Project Name: Starkey Ranch MPUD

STARKEY RANCH MPUD
NON-SUBSTANTIAL MODIFICATION
PROJECT NARRATIVE

RE: Starkey Ranch MPUD (RZ7078)
Non-Substantial Modification Application

TYPICAL 45'x148' LOT
NOT TO SCALE

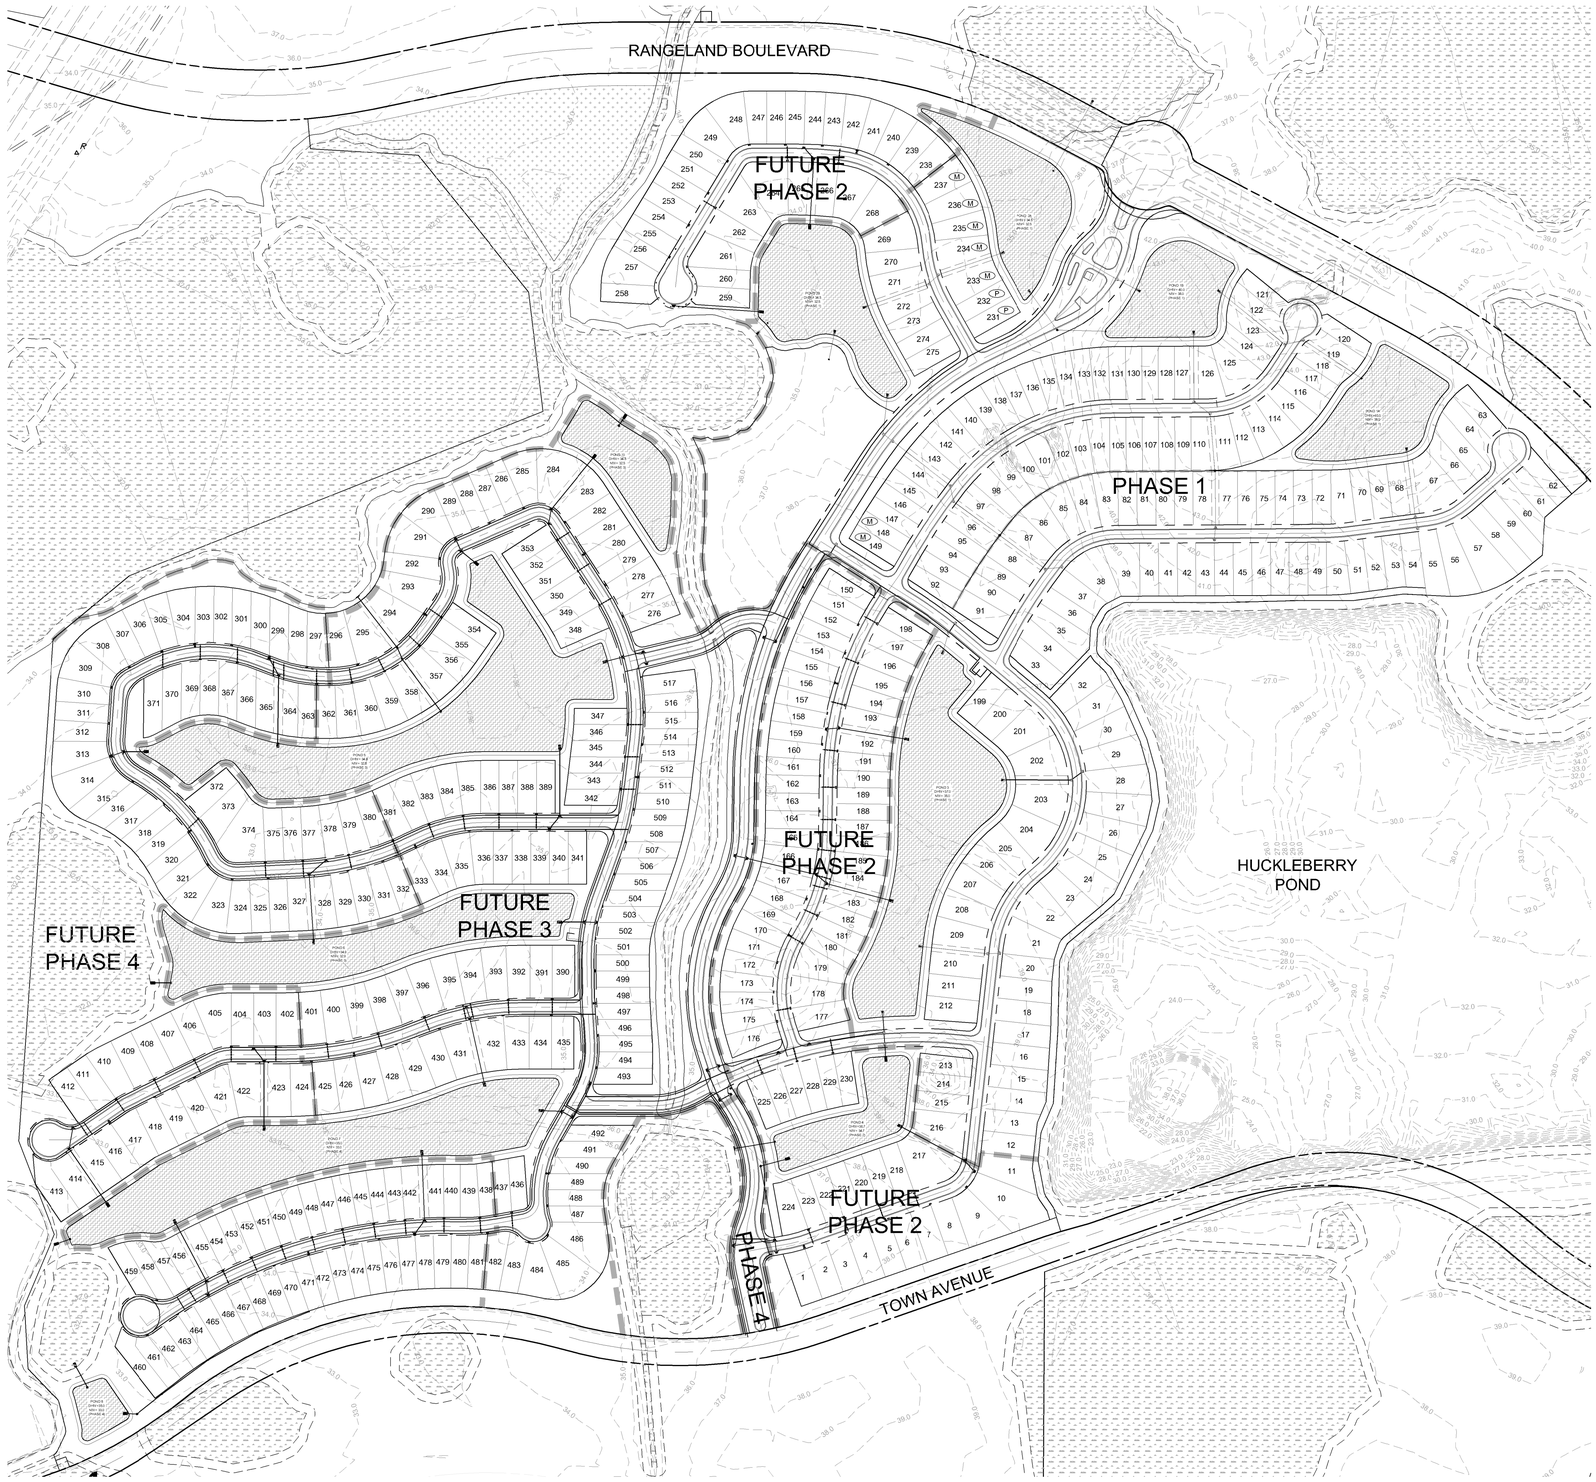
This is accomplished by requiring A/C pads to only be located on the 10' side yard. The A/C pad is 3'x3' and is 0.5' from the building, therefore it is 3.5' into the 10' side yard leaving 6.5' available for drainage in addition to the 2' side yard on the adjacent lot, totaling an area of 8.5' for side yard drainage.

Per county code a minimum of 7.5' side yard setbacks are required to have A/C pads in the side yard. Note there are no restrictions preventing the A/C pads of two lots to be adjacent. In this condition there would only be 8' between A/C pads (assuming 15' between buildings, 7.5' side yard setbacks and 3.5' encroachment on each side for A/Cs). This proposed request will provide 0.5' greater separation.

g. No obstruction/service equipment shall be permitted in the side yard between houses. This includes, but is not limited to, air conditioning systems, water softeners, pump, fences, etc. Where single-family detached product types are developed to conventional standards with 2'/10' side yard setbacks (12' Minimum Building Separation), as shown in Attachment C (Default Standards), air conditioning systems shall be permitted within the side yard containing the 10' minimum setback, and shall not be permitted within the side yard containing the 2' minimum setback.
